SB-GA8-2011-69

Issue 3

Service Bulletin

Modification of Co-pilot Control Column

Figure 1 – Dual Control Column Removal

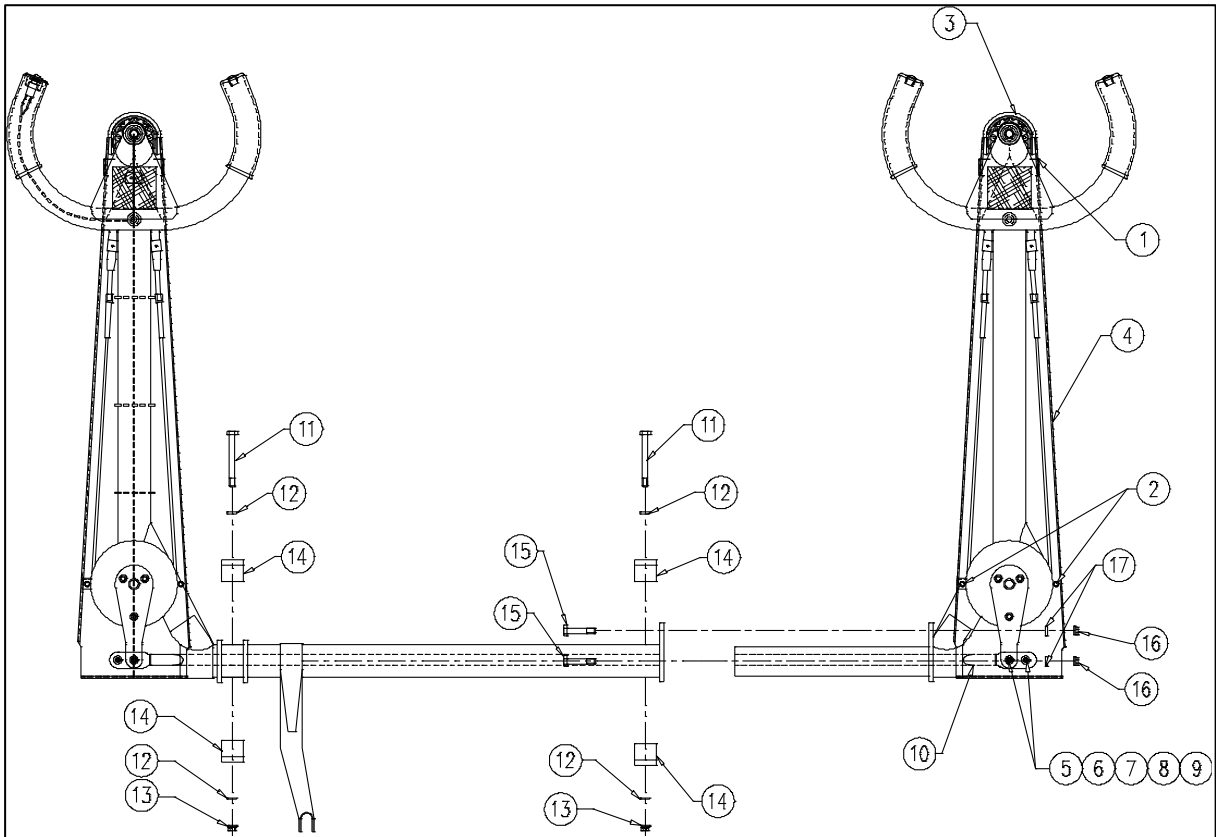
1. Loosen and remove the Screws (1), Screws (2) and then remove the Control Column Top Cover (3) and Control Column Cover (4);
2. Remove the Split Pins (5) and loosen and remove the Clevis Bolts (6), Nuts (7), Washers (8) and Bushings (9) to disconnect the Dual Control Aileron Link Rod (10) from the right hand aileron operating cable and right hand control column;

3. Remove the forward inboard floor access panels to gain access to the left and right hand control column bearing block attachment bolts and nuts;
4. Loosen and remove the Bolts (11), Washers (12) and Nuts (13) and remove the four Half Bearing Blocks (14);

5. Loosen and remove the Bolts (15), Nuts (16) and Washers (17);
6. Disconnect the co-pilot PTT loom (if installed);
7. Remove the right hand control column;

10. After the drying time of 2 hours, place the right hand control column back to the original assembly;
11. Re-install the four Half Bearing Blocks (14) by using the original hardware and torqueing the Bolts (11) to 70 in.lb;

12. Re-install the forward inboard floor access panel;
13. Re-install the Dual Control Aileron Link Rod (10) to the right hand aileron operating cable by using original hardware;

Figure 2 – Co-pilot torque tube modified dimension

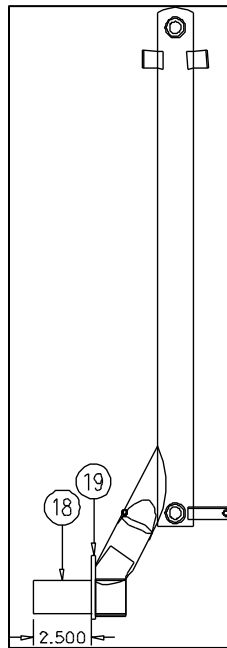
8. Measure the co-pilot torque tube (18) from the joining flange (19) up to 2.5 inches and then cut the remaining tube as per indicated in Figure 2;
9. Prime the cut area with a mixture of Durepon P14, code 410-33226, mixing ratio = 4 and Durepon P14, code 980-50259, mixing ratio = 1;
